STERLING RANCH PHASE 2

EARLY GRADING AND EROSION CONTROL PLANS

JUNE 2020

PCD Filing No.: SP-20-003

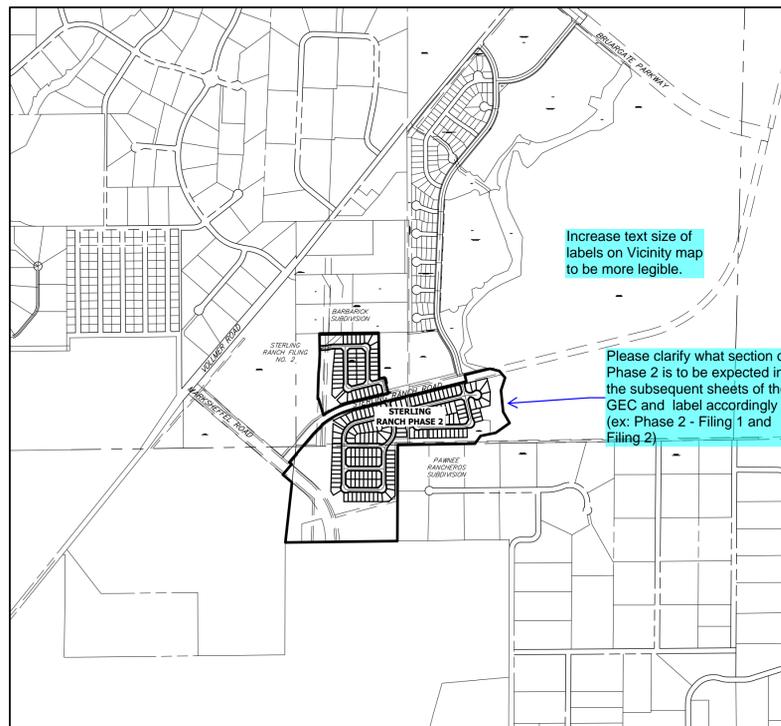
Add in Soils report author and date

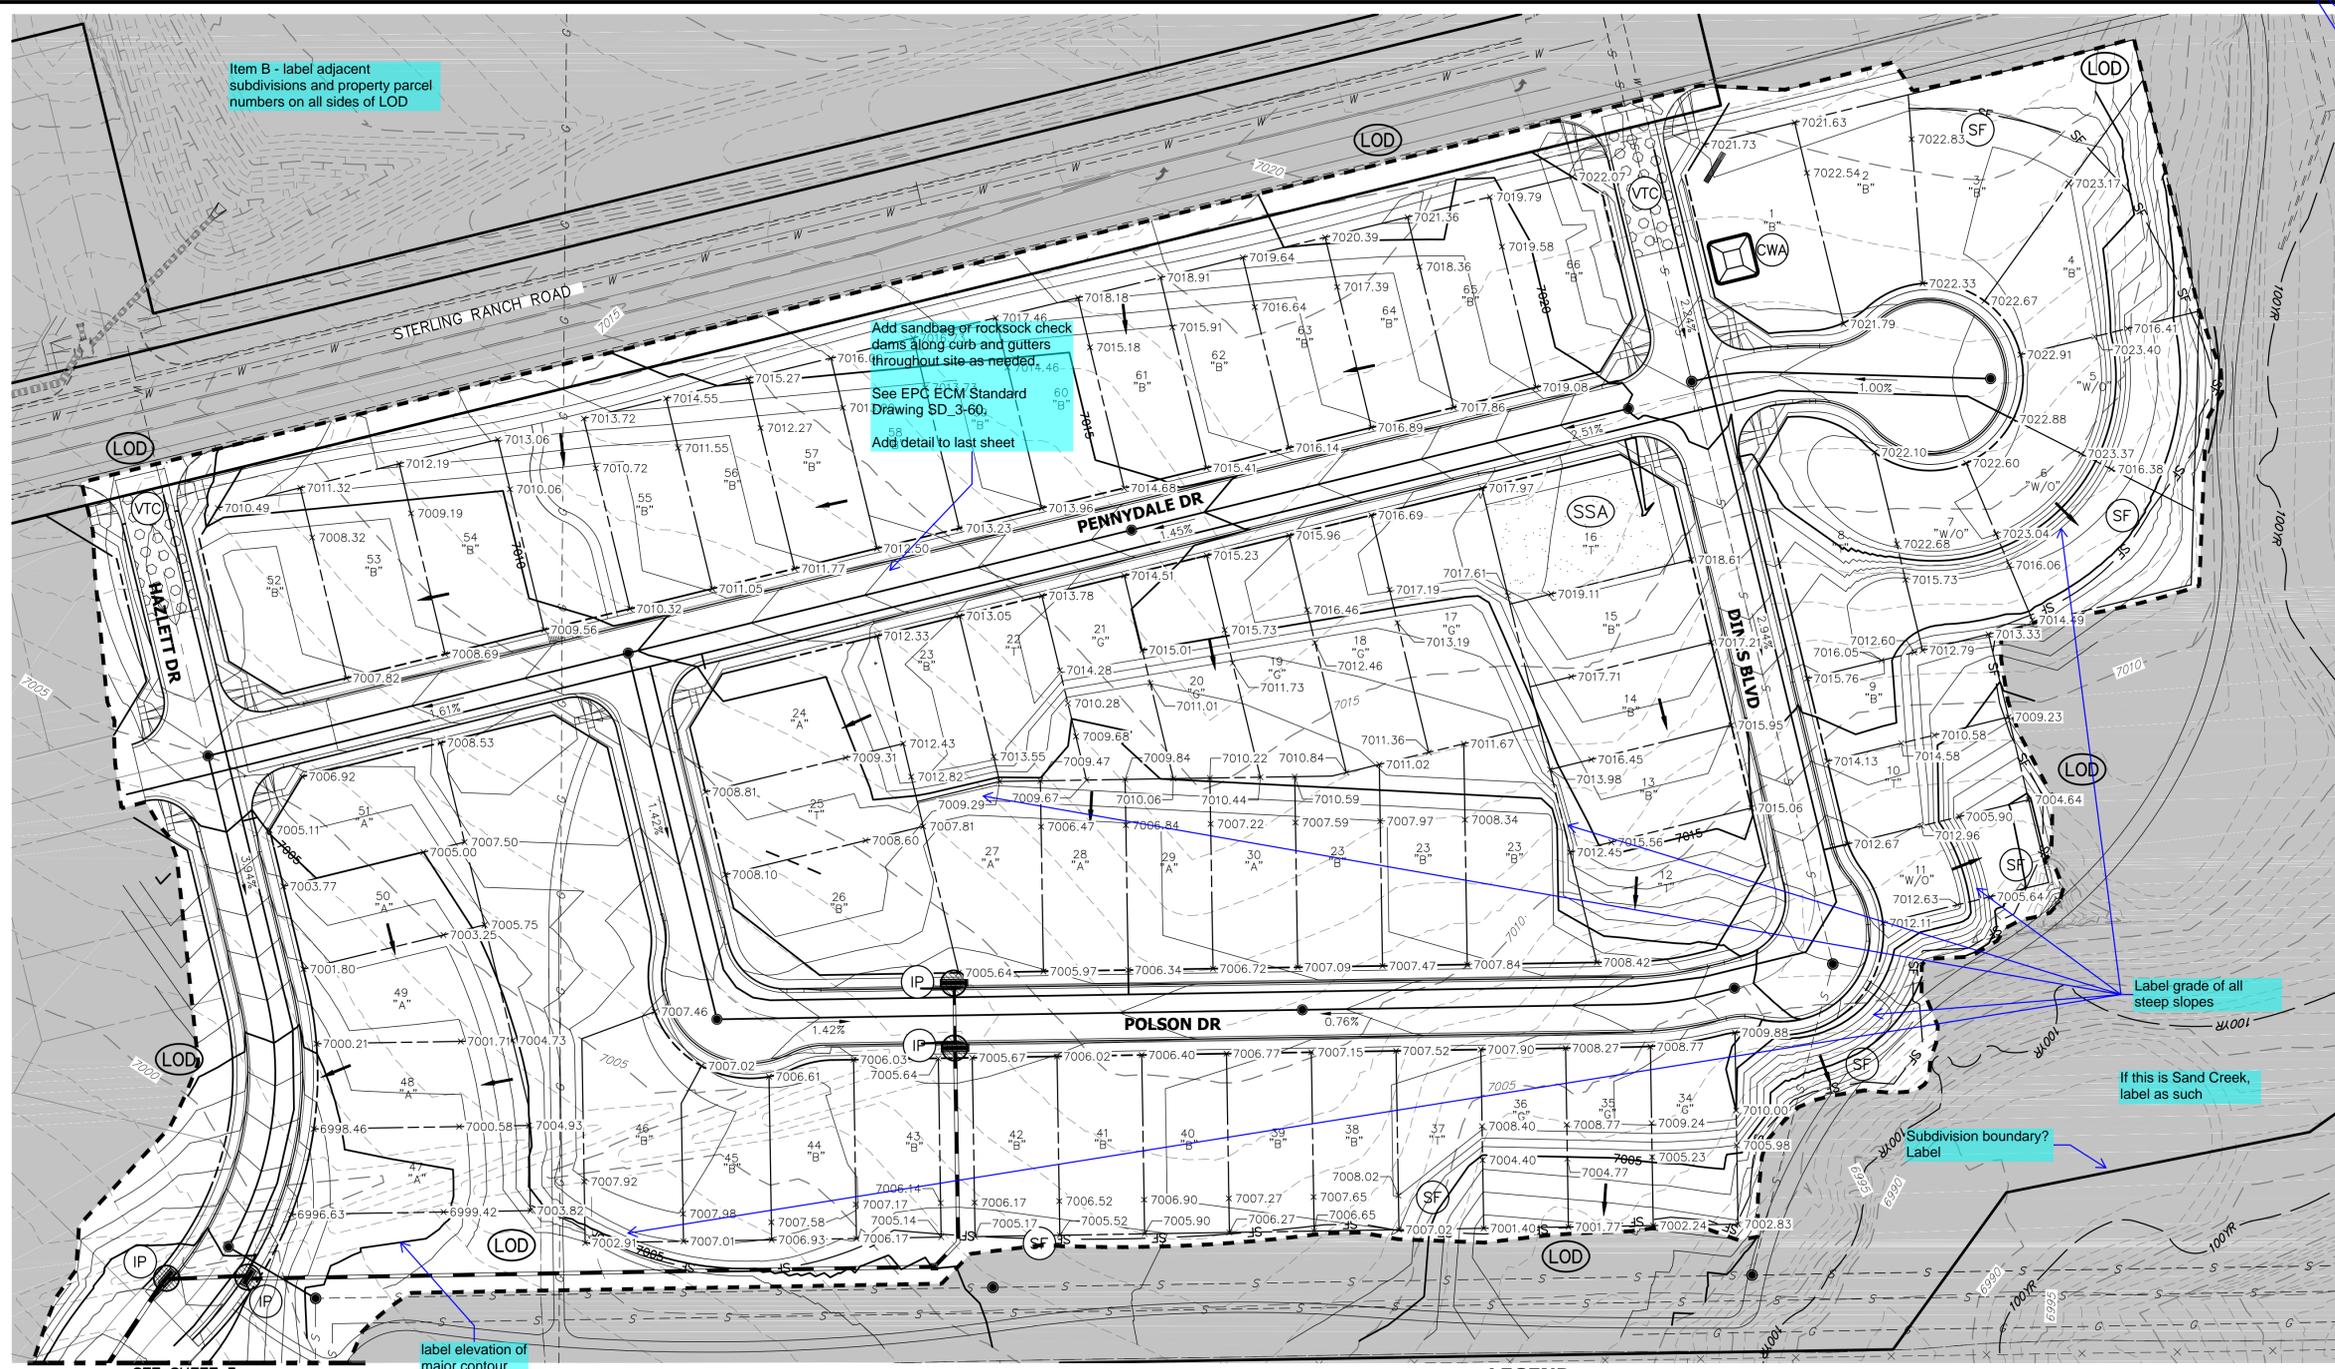
Item B - label adjacent subdivisions and property parcel numbers on all sides of LOD

Add sandbag or rocksock check dams along curb and gutters throughout site as needed
See EPQ ECM Standard Drawing SD_3-60.
Add detail to last sheet

Show outlines of Sheet 2 and 3 on here

Label grade of all steep slopes

If this is Sand Creek, label as such

Subdivision boundary? Label

label elevation of major contour

GRADING AND EROSION CONTROL PLAN

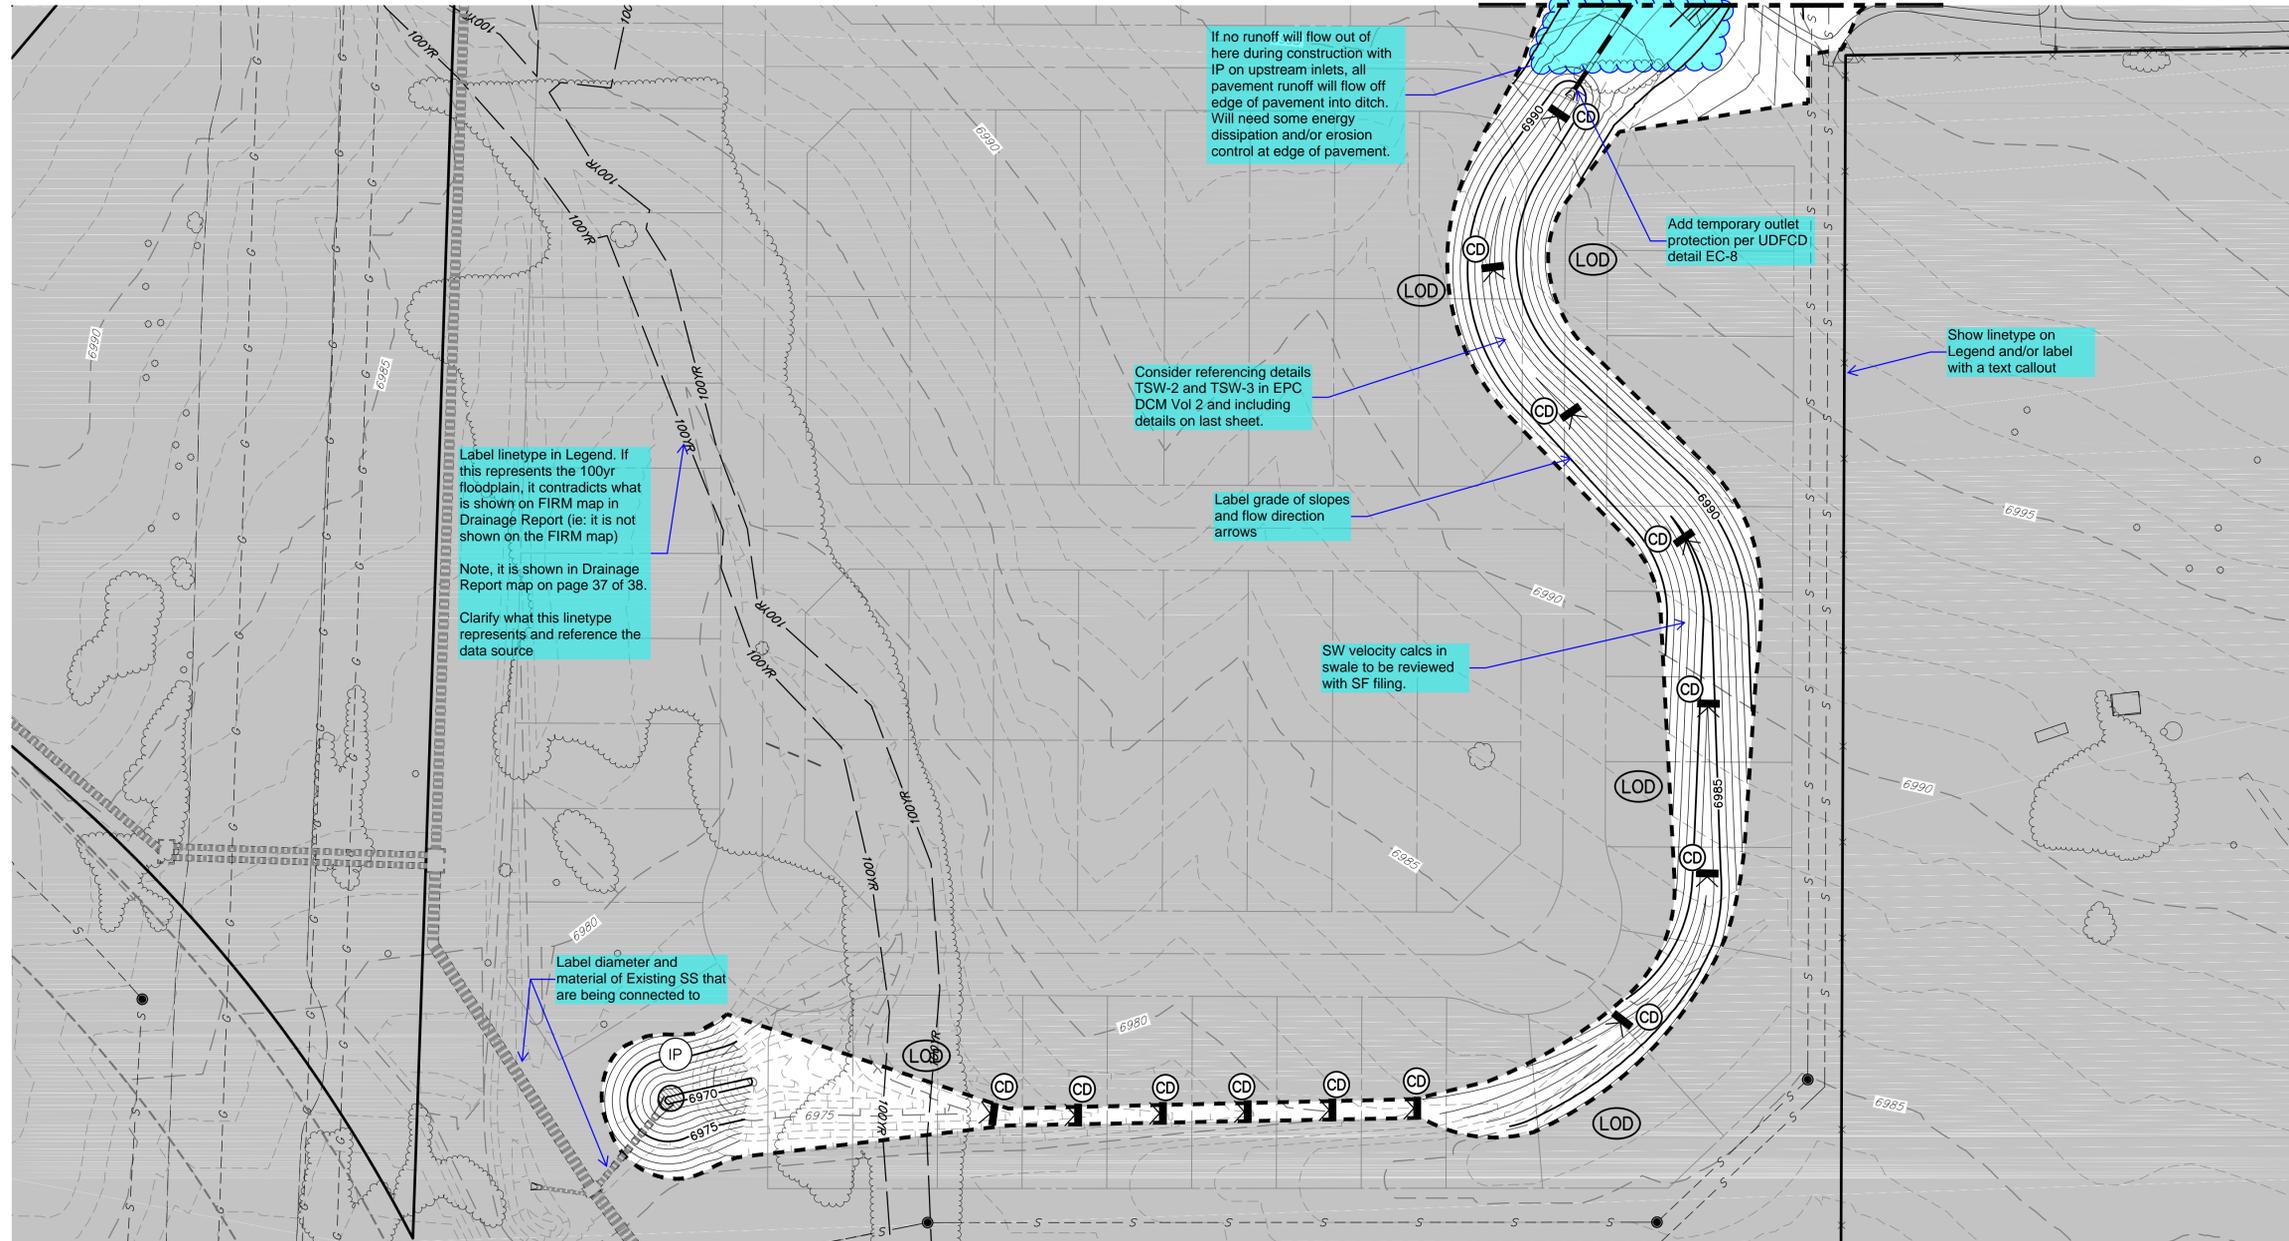
Make the linetypes for property lines to the CAD standard P/L linetype for clarity

Revise to: Stabilized Staging Area

line needs to be clearly labeled in plans with cut/fill text shown on either side of line. Did not see it already on plans

Item E - show subdivision boundary

Show location on plans and symbol in legend for:
- TS/PC
- RECP
